Report to **Development Permit Panel**

DP 05-312653

Application by Patrick Cotter Architect Inc. for a Development Permit at

12251 No 2 Road

3. Lack of Landscaping at the Project Entrance

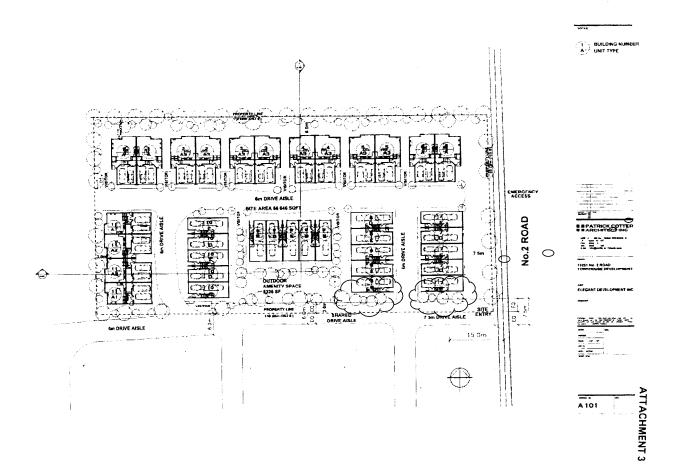
At the rezoning stage the applicant proposed four [4] trees at the project entrance for the first two blocks. The City of Richmond wanted our project and this project to have a shared entrance which was complied with and we prepared all the necessary documents associated with that requirement. Our landscape plan incorporated a street fronting character to articulate the entrance way. From what we had seen of the adjacent rezoning application they also proposed landscaping so that the project entrance would have landscaping on both road frontages. Now, at the development permit stage, there is almost no landscaping with the exception of a few grasses and some scrubs, no trees, exposing the entire side building elevation of Building 7, which is three-storeys in height. We respectfully suggest that the entrance requires more screening and a proper street fronting character.
